**Sha Tin New Town, Stage II**  
**Contract No. ST 79/02**  
**Road T3 and Associated Roadworks**

**Submission of Amendments to Landscape Proposal**

Amendments to Landscape Proposal in the  
Landscape and Visual Impact Assessment (July  
2007)

(Tai Po Road – Sha Tin Slip Road, Near Scenery  
Court)

**Annex A – Part Print of Drawing no.  
63494/200C (General View of T3  
Mainline near Scenery Court)**

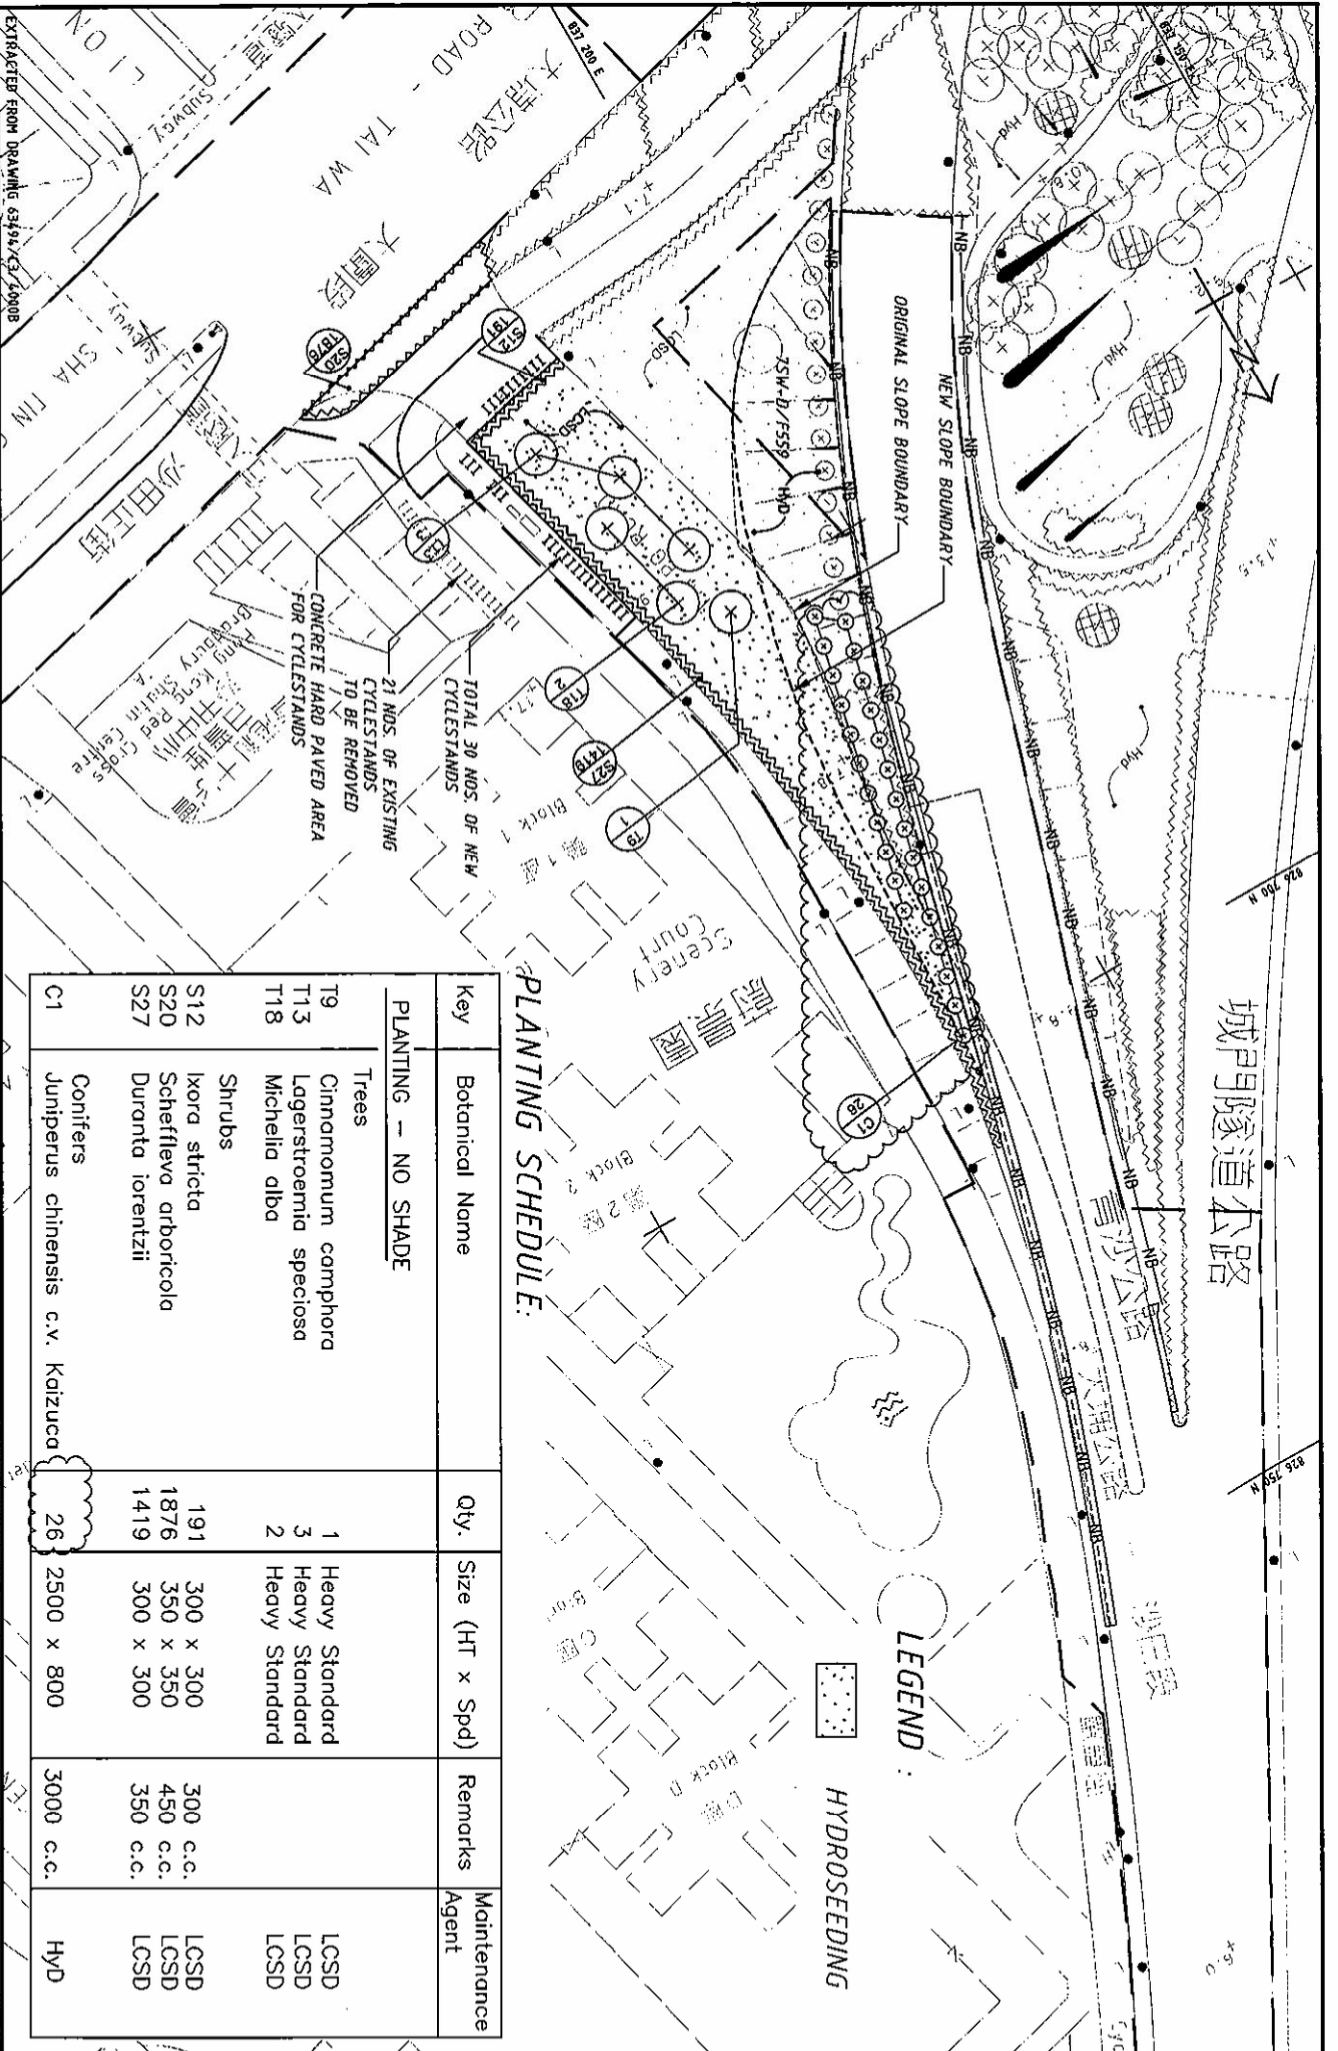
As per Drawing no. 63494/2005C in Appendix M in the agreed LVIA Report (July 2007), soft landscape treatment is proposed at the sloping and permanently close slip road area adjacent to the T3 Mainline near Scenery Court, Sha Tin. Part-print of Drawing no. 63494/2005C focusing only at the amenity area adjacent to T3 Mainline near Scenery Court is attached as Annex A for easy reference.

The original design of civil works and soft landscaping works at the sloping area adjacent to the T3 Mainline near Scenery Court, Sha Tin is shown in Annex A.

附件： 綠化工程設計圖

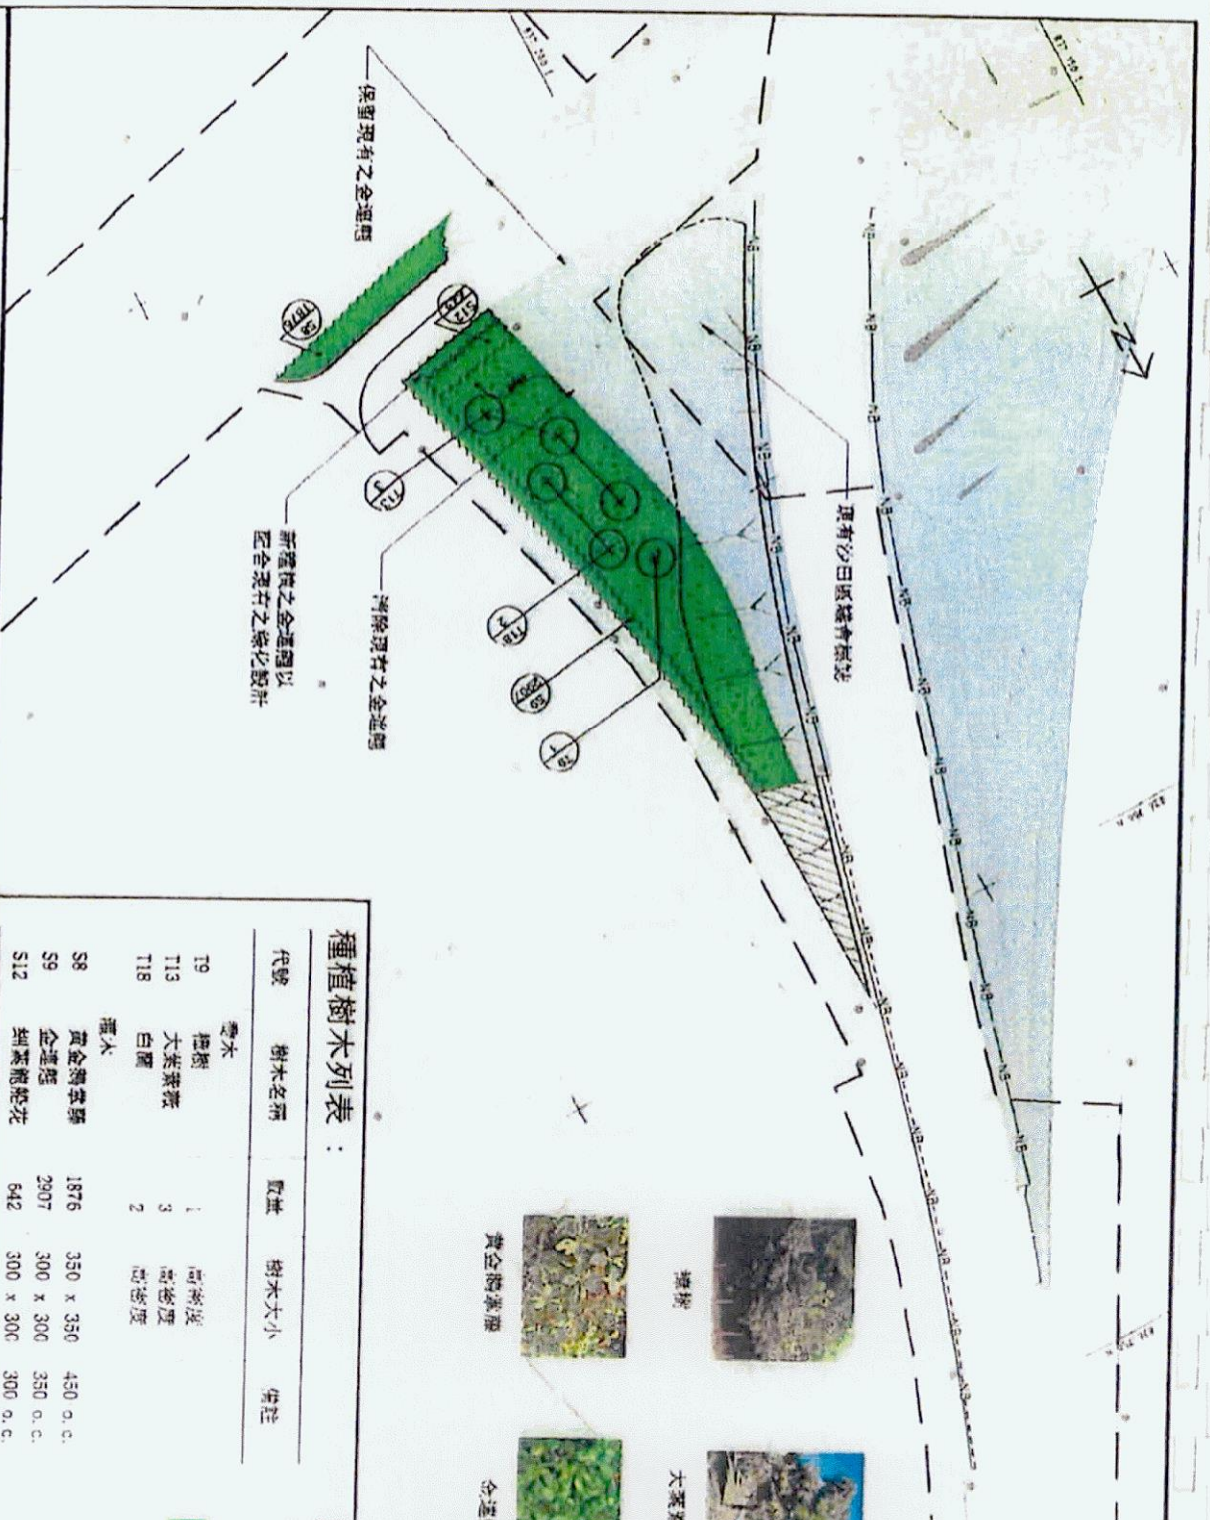
→ It is suggested that the width of a 3-lane road can only house one full-grown *Cinnamomum camphora* instead of 2.

1. S8: *Schefflera arboricola* (花葉鴨腳木) is recommended to replace *Codiaeum variegatum*. The size of shrubs should be in 350 mm x 350 mm.
2. S9: To match with the existing plant, *Duranta lorentzii* (假連翹) should be used instead of *Duranta repens* "Golden leaves" (金連翹). Size should be in 300 mm x 300mm.

Pls be informed that we have revised the attached site sketch with reference to your comments. Then, we will circulate to DC members later.
